NOTICE TO APPLICANTS ADDENDUM NO. Four (4)

Florida Gulf Coast Marine Fisheries Hatchery and Enhancement Center DEP Bid NO. BDC13-17/18

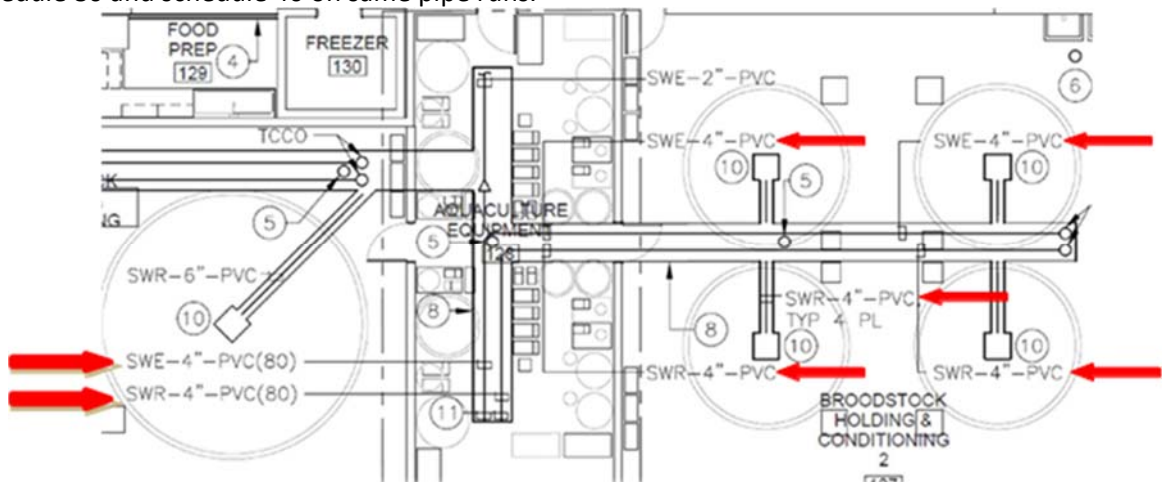
91. RFI: Aquacultural Systems: Please clarify type of piping system required in Section 13 for the LSS ozone and oxygen lines. Please advise if schedule 40 316SS pipe is acceptable or if 316SS seamless instrumentation grade tubing is required. No specifications listed for stainless steel pipe and fittings.

Response: Stainless steel piping for ozone and oxygen service shall meet the requirements of NFPA 99 and ASTM A312. Piping (pipe, valves and fittings) shall be manufactured, cleaned, purged and sealed for oxygen service. System working pressure is 50 psig. Instrumentation grade tubing is not required.
